Title of Change:	Change in carrier tape design for ASEKS SOIC8L Devices.
Effective date:	25 Oct 2019
Contact information:	Contact your local ON Semiconductor Sales Office or Marquita.Jones@onsemi.com
Type of notification:	This Product Bulletin is for notification purposes only. ON Semiconductor will proceed with implementation of this change upon publication of this Product Bulletin.
Change Category:	Test Change
Change Sub-Category(s):	Shipping/Packaging/Marking

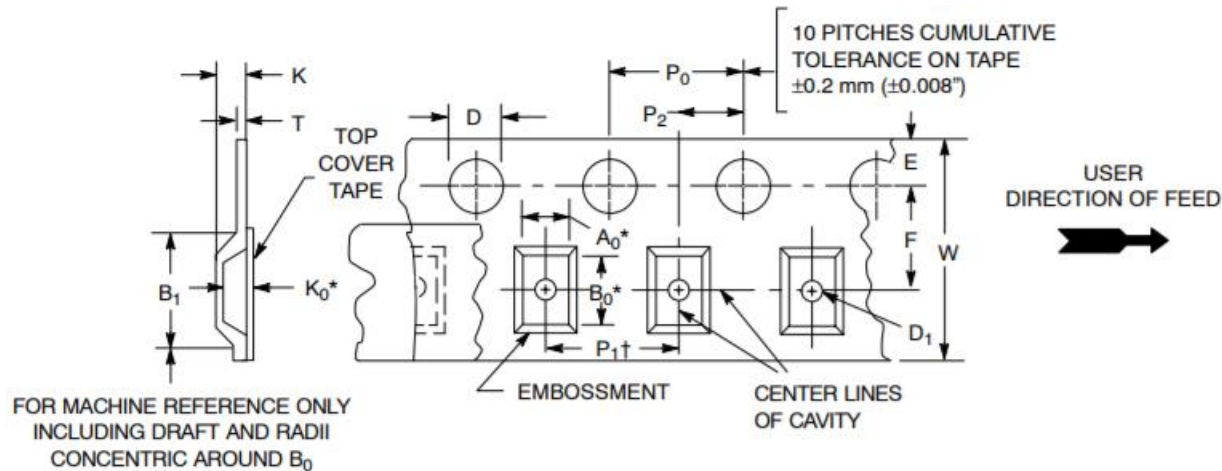
The purpose of the new design is to minimize the movement of the devices inside the pockets of the reel. A Rib (fence) was provided in the pocket to suppress movement of the device. There are no changes to the vendor and there are no changes to the final reel quantities and packing specifications.

Material to be Changed	Before Change Description	After Change Description
A0 Dimension K0 Dimension K1 Dimension	6.9mm 2.0mm 1.7mm	6.55mm 2.1mm 1.8mm
Carrier Tape Design

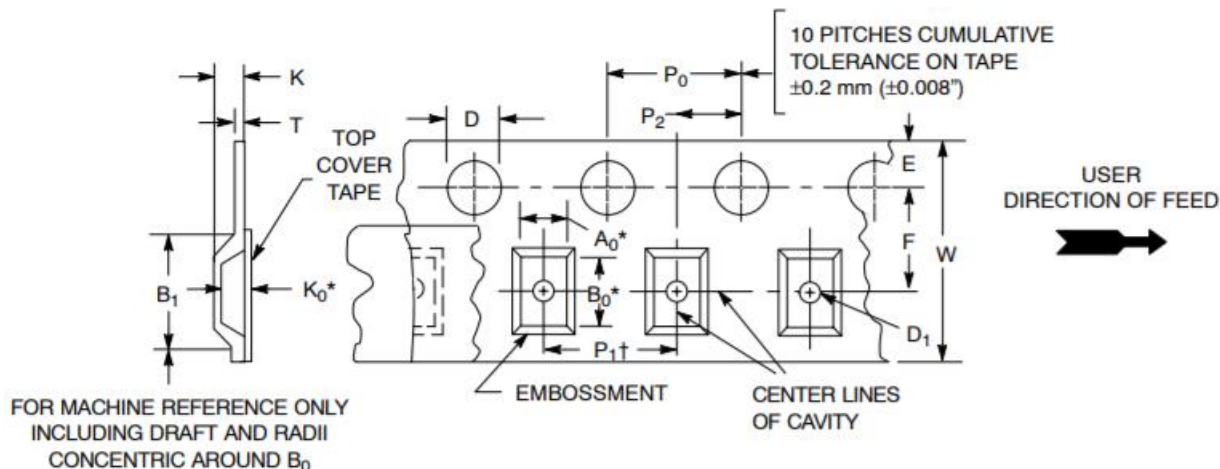
新規設計は、リールのポケット内での製品の移動を最小にすることを目的としています。リップ (フェンス) がポケット内に設けられて製品の動きを抑制します。バンダーの変更はなく、また最終リール収納数および梱包仕様にも変更はありません。

変更される材料	変更前の表記	変更後の表記
A0 サイズ	6.9 mm	6.55 mm
K0 サイズ	2.0 mm	2.1 mm
K1 サイズ	1.7 mm	1.8 mm
キャリアテープ設計
